City of Mount Vernon
Design Review Board
Minutes – August 19, 2021

PUBLIC MEETING FOR PROPOSED FAÇADE AND SITE CHANGES TO 508 S 2ND STREET

PERMIT NUMBER:	PLAN21-0294		
PROJECT ADDRESS:	508 S 2 nd Street	PROJECT PARCEL NUMBERS:	P52080
APPLICANT:	Mark Christ		
PROJECT DESCRIPTION:	Phased project to result in 1,820 s.f. of professional office space, seven new apartments (7,946 s.f. of interior remodeling will create five (5) of the units and a 3,196 s.f. addition to the third floor will create the additional two (2) units), and new improvements including: an apartment lobby, elevator, outdoor roof deck, parking areas, dumpster enclosure, common outdoor space, and landscaping.		
APPLICABLE MVMC	MVMC CHAPTERS 17.70, 17.48, 17.84, 17.93 AND CHAPTER 14.05

Improvements to 508 2nd Street
for RPI Mount Vernon LLC

A North Elevation
1/8"=1'-0"

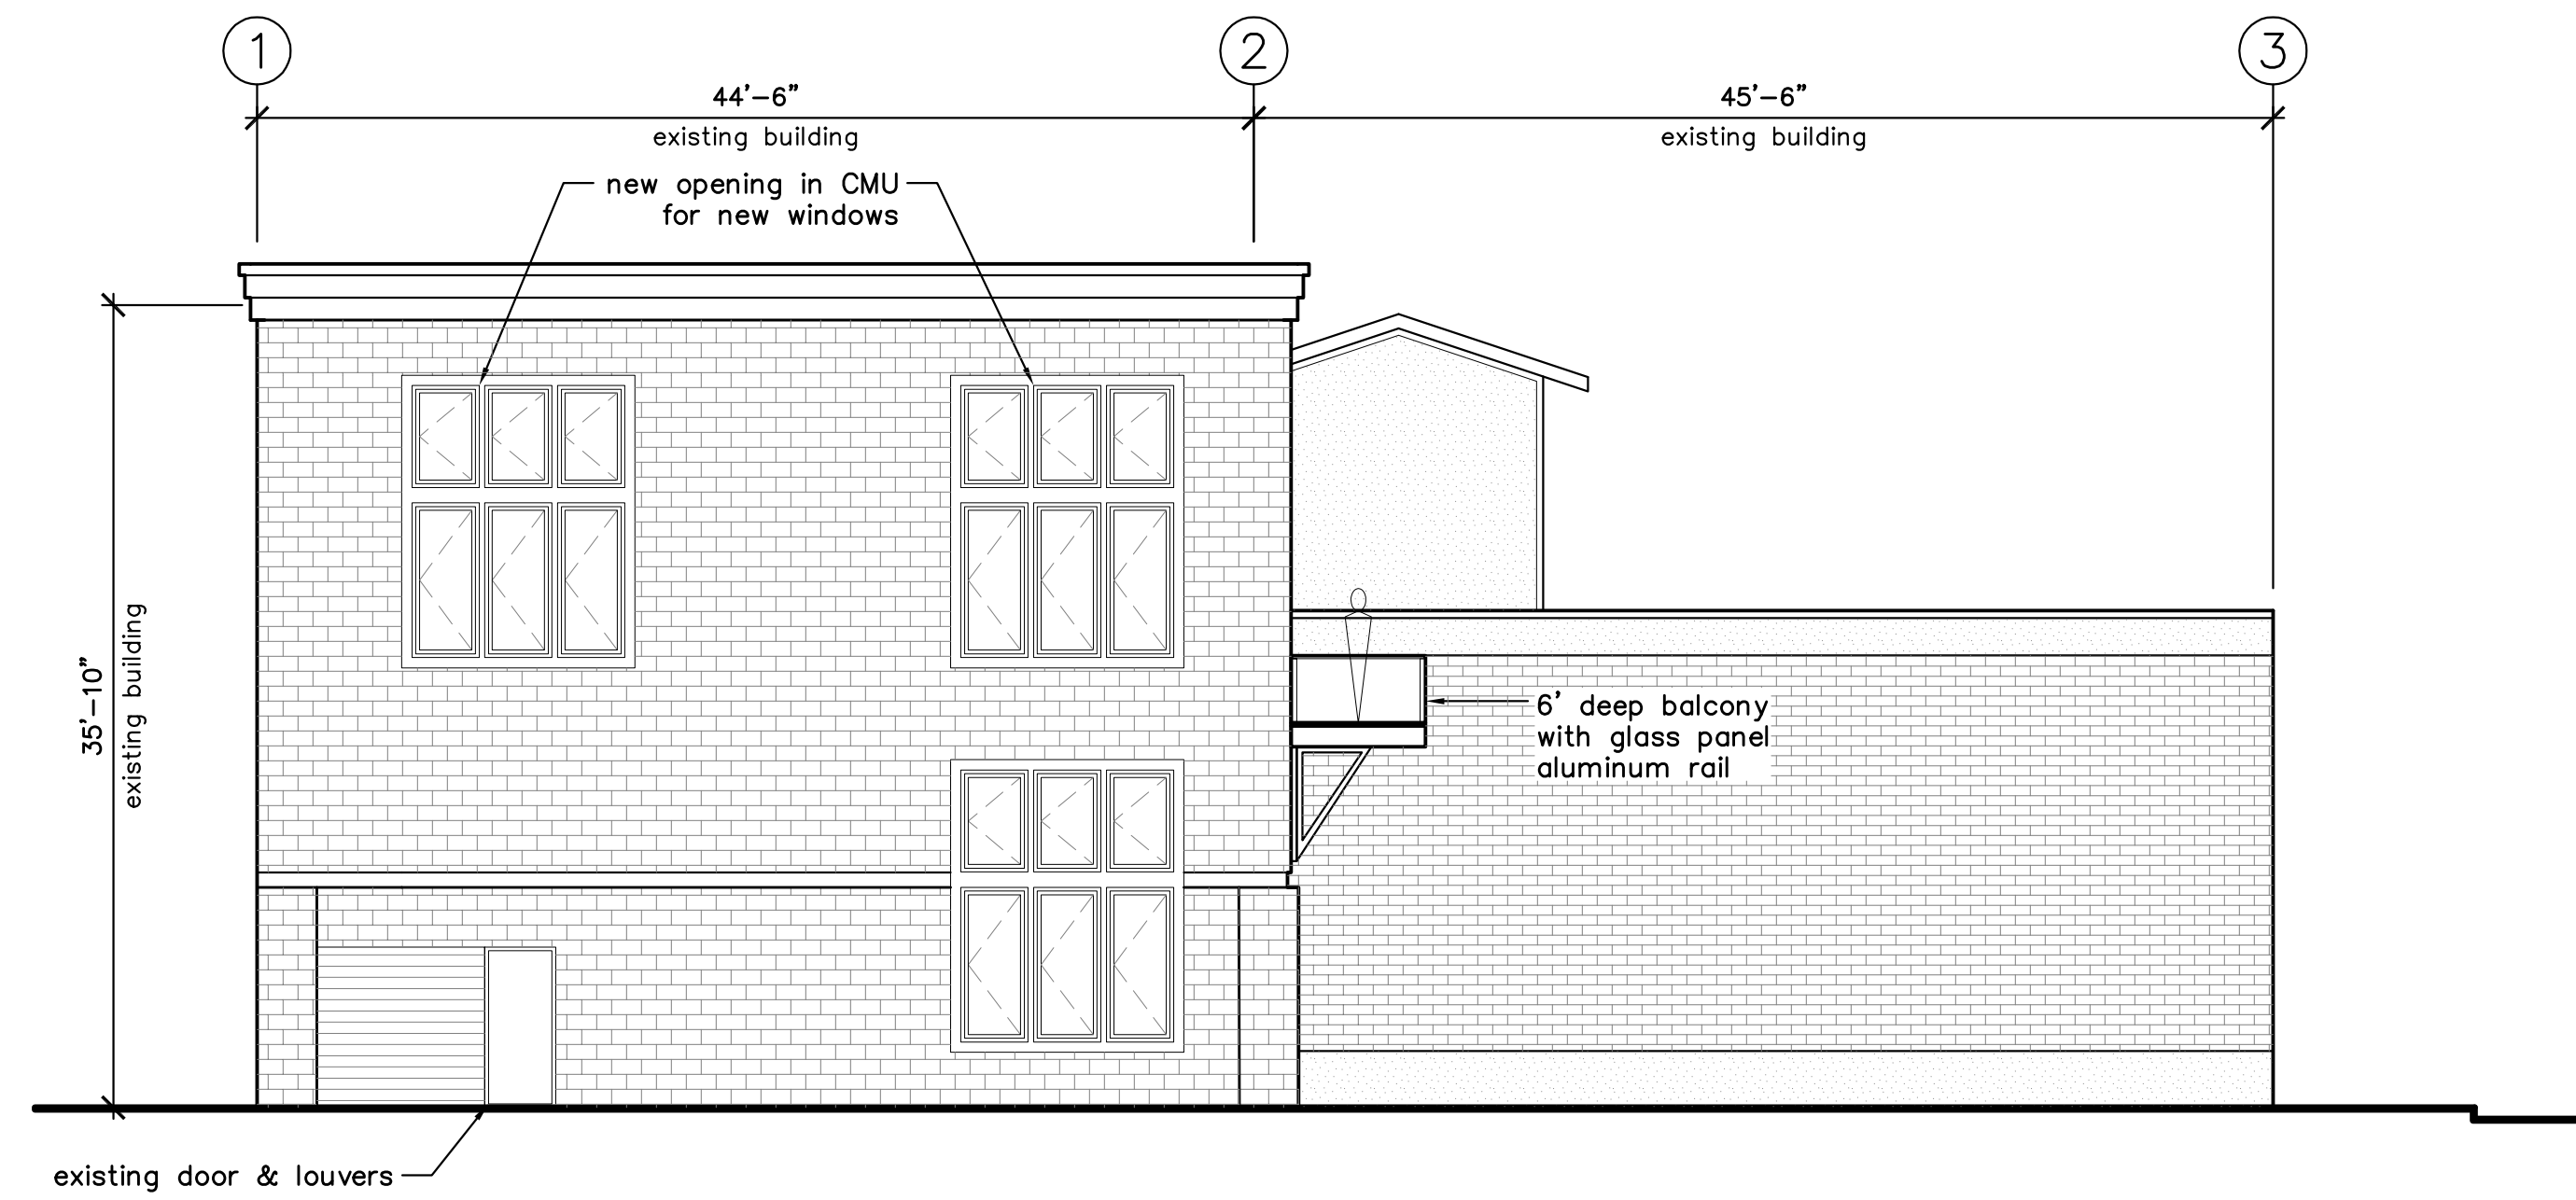
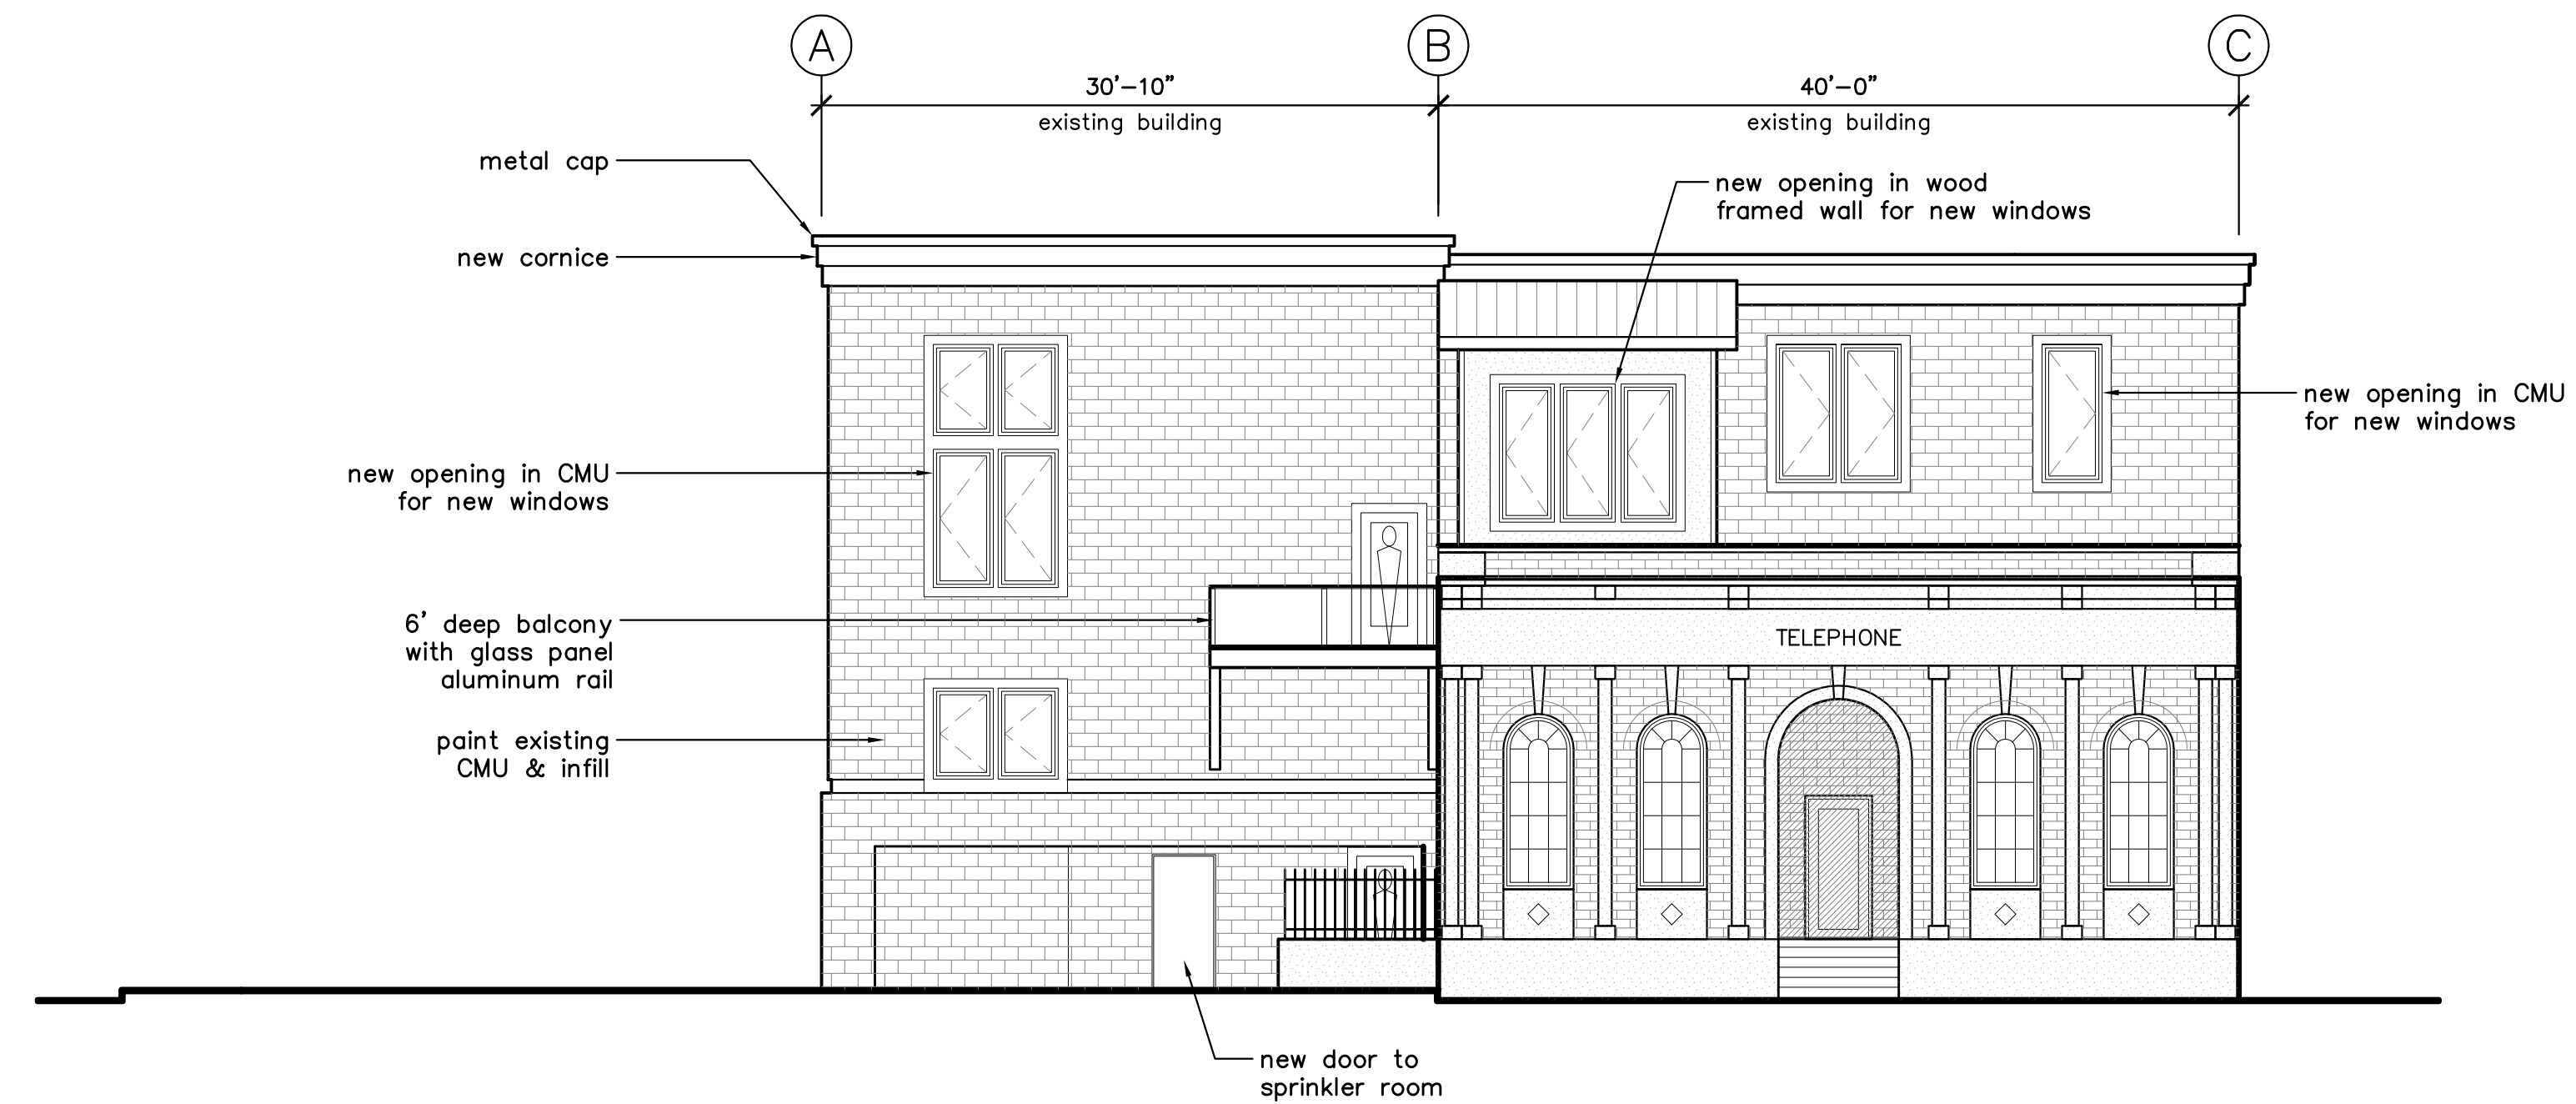
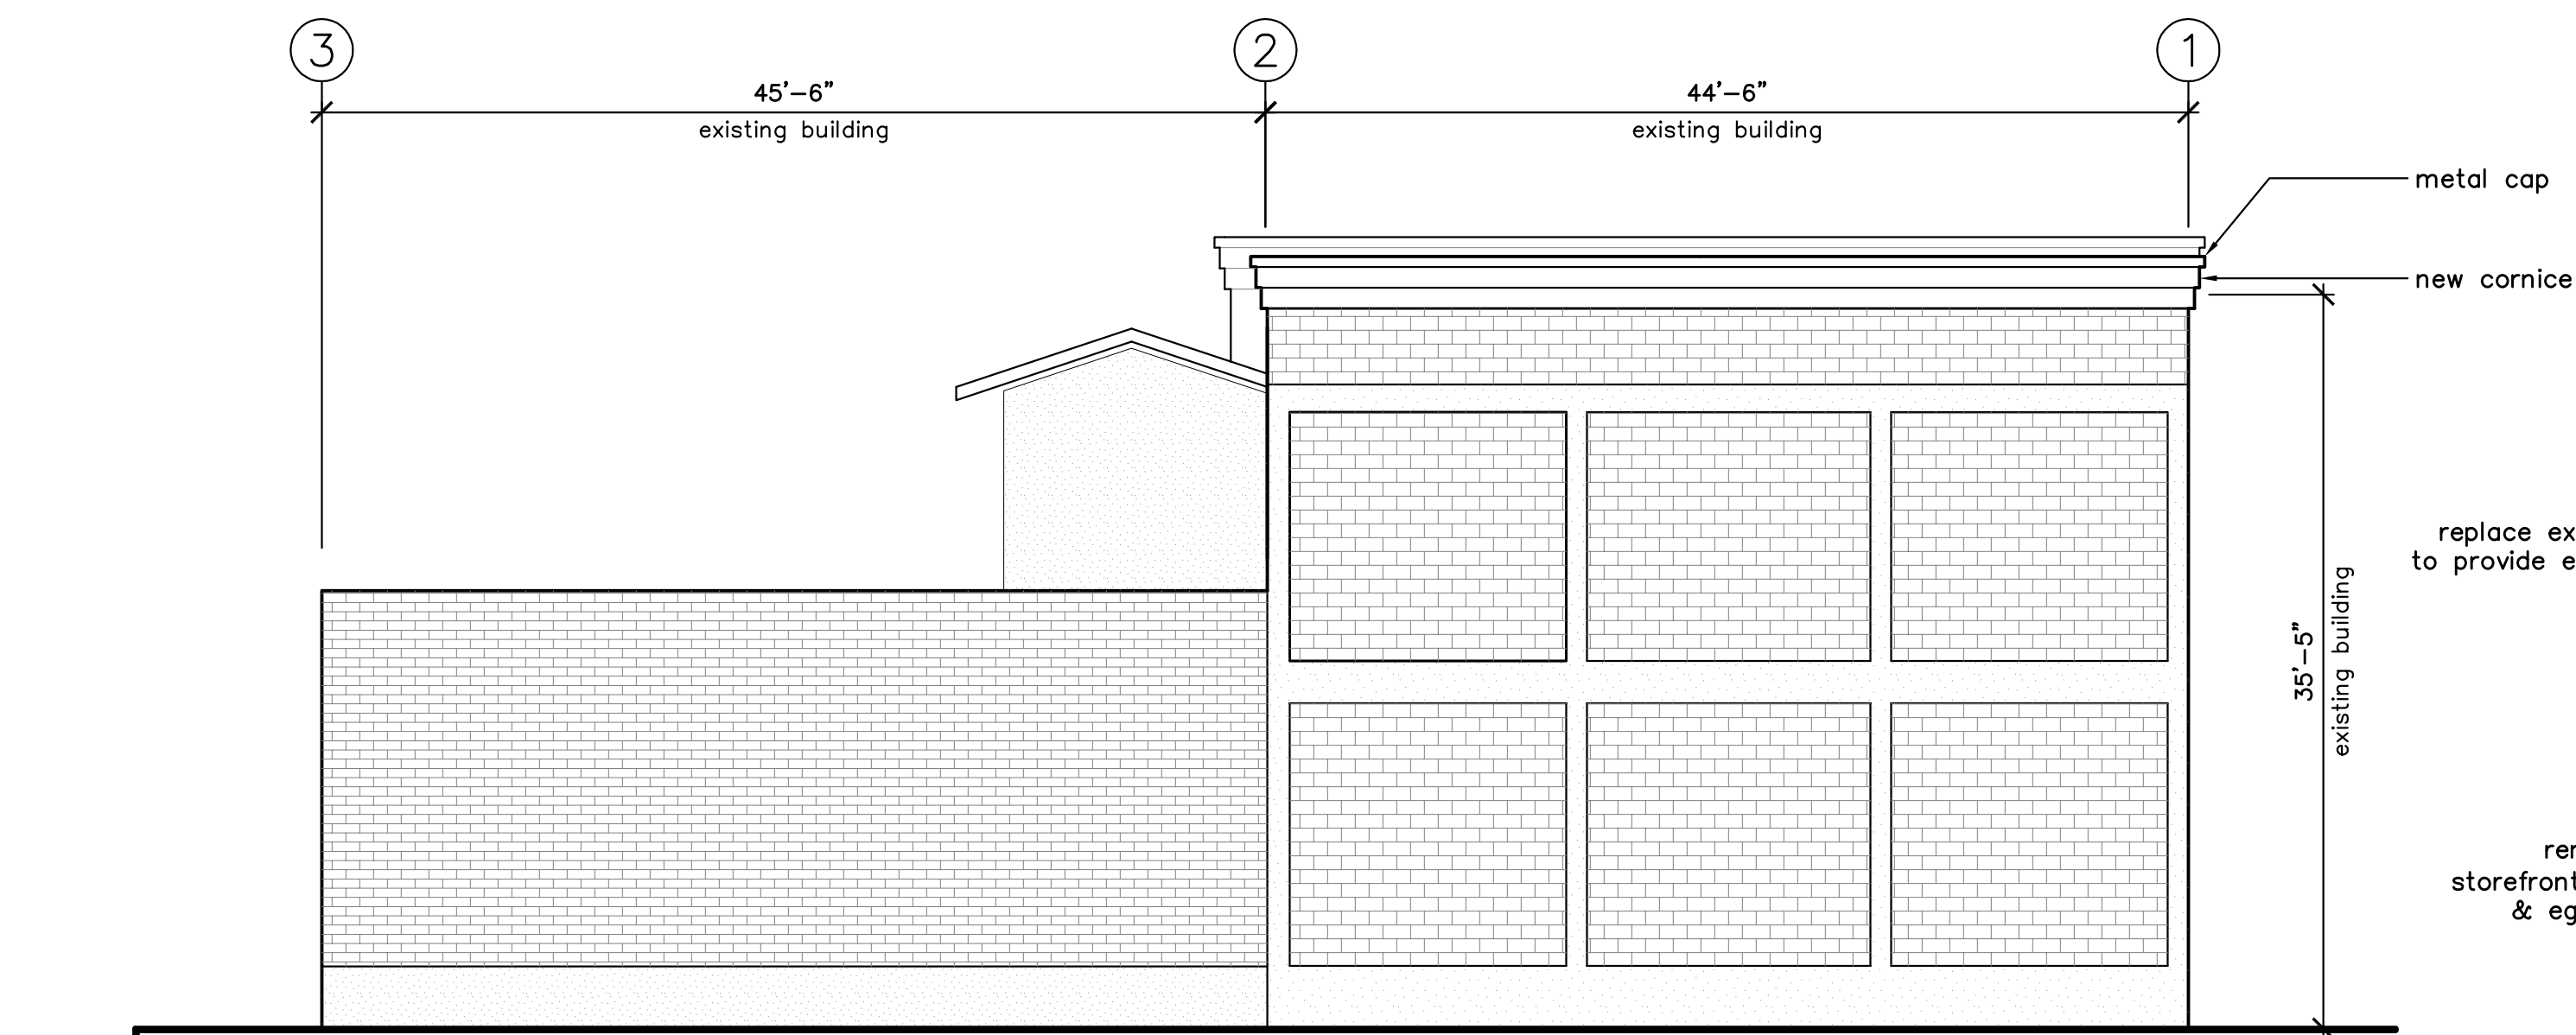
The proposed individual windows have a vertical proportion of approximately 2:1 (height to width). The Applicant will need to verify that all of the windows will be surrounded by trim, molding, sills or other architectural features and that they recess or project at least three-inches from the façade.

The Applicant will need to verify what they plan on doing to the north, east, and south facades of the structure because staff is not sure if the existing paint will be removed from the brick or not.

Staff recommends approval of a waiver for the west elevation of the structure because it is only 1.6% short of meeting the glazing requirement. Staff recommends the Applicant be required to submit revised plans bringing the north and south elevations closer to complying with the glazing requirements. Further, staff recommends the Applicant be required to submit revised drawings identifying which of the listed elements are being satisfied for 50% of more of the windows.

- b. The requirement for windows to comprise no less than 15 percent of the building façade outlined in Design Standard DT-E on the north, west, and south elevations of the structure. The Board recommends the Applicant be required to submit revised plans bringing the east elevation closer to complying with the glazing requirements. Further, the Board recommends the Applicant be required to submit revised drawings identifying which of the listed elements are being satisfied for 50% or more of the windows.

- a. Demonstrating all of the windows will be surrounded by trim, molding, sills or other architectural features and that they recess or project at least three-inches from the façade.
